APPLICATION NO.	FILING DATE	FIRST NAMED INVENTOR	ATTORNEY DOCKET NO.	CONFIRMATION NO.
10/598,994	09/18/2006	Marc Peuker	59607US005	3030
32692	7590	12/24/2008	EXAMINER	
3M INNOVATIVE PROPERTIES COMPANY			PAGAN, JENINE MARIE	
PO BOX 33427				
ST. PAUL, MN 55133-3427			ART UNIT	PAPER NUMBER
			3728	
			NOTIFICATION DATE	DELIVERY MODE
			12/24/2008	ELECTRONIC

Office Action Summary	Application No.	Applicant(s)	
	10/598,994	PEUKER ET AL.	
	Examiner	Art Unit	
	JENINE M. PAGAN	3728

DETAILED ACTION

FIG. 4

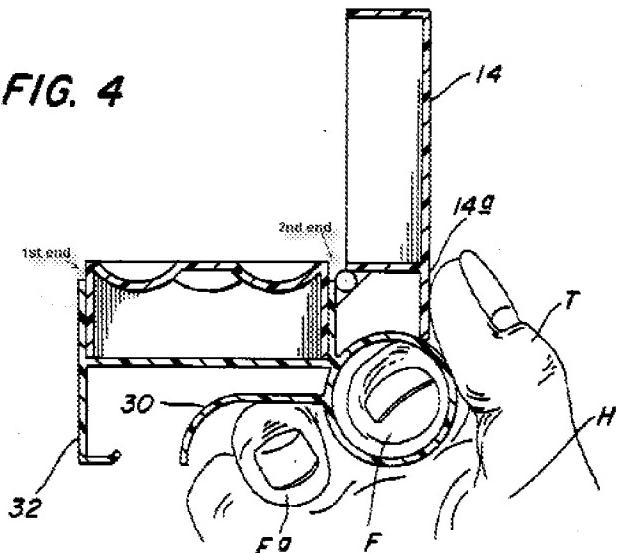
10. Claims 55-59, 61, 62, 84, 87, 89 and 90 are rejected under 35 U.S.C. 102(b) as being anticipated by McGarrigle (US 5,249,963).

Claim 55: McGarrigle discloses a package assembly for storing and delivering dental substance:

- at least one container 10 comprising a base 12 and a lid 14; and
- at least one hinge 16/18 connecting the base 12 and the lid 14;
- wherein the base 12 and the lid 14 comprise first 14a and second 26/30 levers, the first 14a and second 26/30 levers are provided at the container 10 essentially on the side of the hinge 16/18 with their free ends extending essentially in a direction away from the hinge 16/18; and wherein the container 10 can be opened or the lid 14 can be removed from the base 12 by moving the ends of the first 14a and second 26/30 levers towards each other

Claim 57: McGarrigle discloses a package assembly for storing and delivering dental substance (see figure above and Col 2:42-47):

Claim 62: McGarrigle discloses a package assembly for storing and delivering dental substance (see figure above):

Claim 87: McGarrigle discloses a method of providing dental substance according to claims 55-59, 61, 62 and 84 (Figure 4):

- opening the initial closed package assembly 10 by pressing the two levers 14a/26/30 together, and
- taking the substance (Col 2:39-40) out of the container 10

- closing the container 10 by pressing the lid 14 onto the container (Fig. 4)
